Economic Commission for Europe**Inland Transport Committee****World Forum for Harmonization of Vehicle Regulations****Working Party on Passive Safety****Seventy-eighth session**

UN Regulation No. 127 (Pedestrian safety)

**Proposal for supplement 3 to the 04 series of amendments to
UN Regulation No. 127 (Pedestrian safety)****Submitted by the experts from Germany and the Kingdom of the
Netherlands ***

Annex 1, Part 2, paragraph 16.1., amend the text under the table to read:

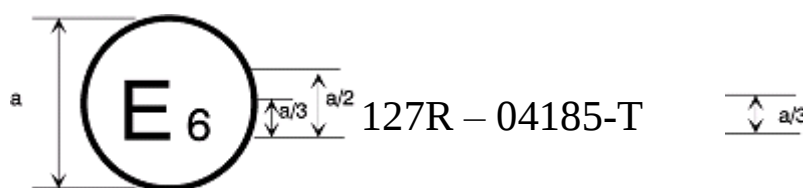
“WAD 2,100 boundary in accordance with paragraphs 11.9. to 11.41.13.: applicable / not applicable.”

Figure 6
Evaluation of resultant acceleration and jerk for tests to the windscreen.

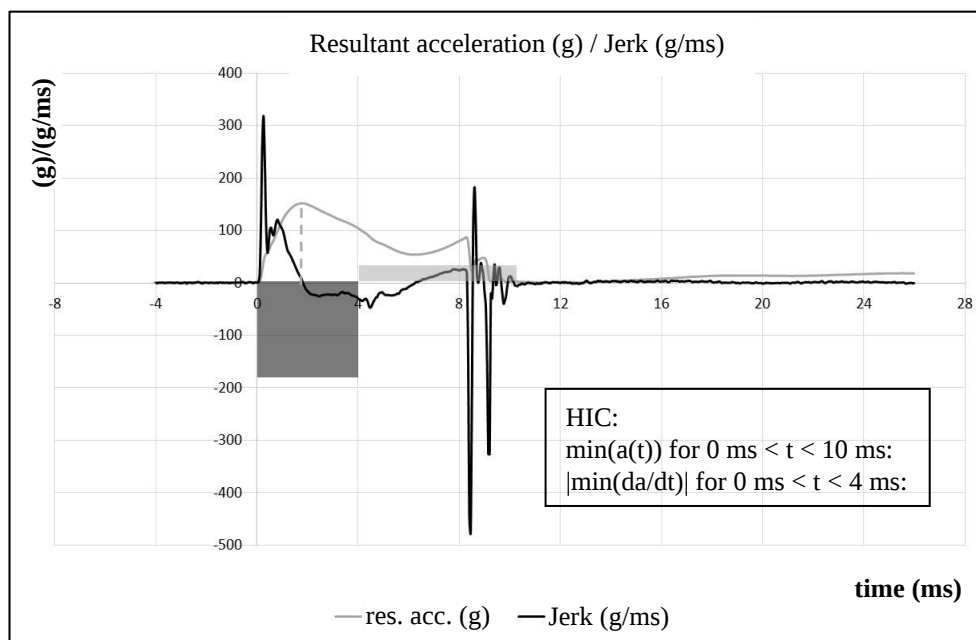
- “4.1. Tests shall be made to the front structure within the boundaries as defined in paragraph 2.16. of this Regulation. Test shall also be made to the windscreen within the boundaries as defined in paragraph 2.44. **For all tests to the windscreen, resultant acceleration versus time and jerk (derivation of the resultant acceleration) versus time histories must be provided and evaluated against the atypical fracture criteria according to paragraph 2.48. (see Figure 6) and reported for monitoring purpose according to paragraphs 4.8. to 4.10.** For tests on the rear area of the bonnet top, the headform impactor shall not contact the windscreen or A-pillar before impacting the bonnet top. For tests on the windscreen, the headform impactor shall not directly contact the A-pillars, windscreen header and cowl, except in the case of monitoring testing.

Note: Both alternatives, 1 graph for each criterion or 1 graph for both criteria, are accepted.”
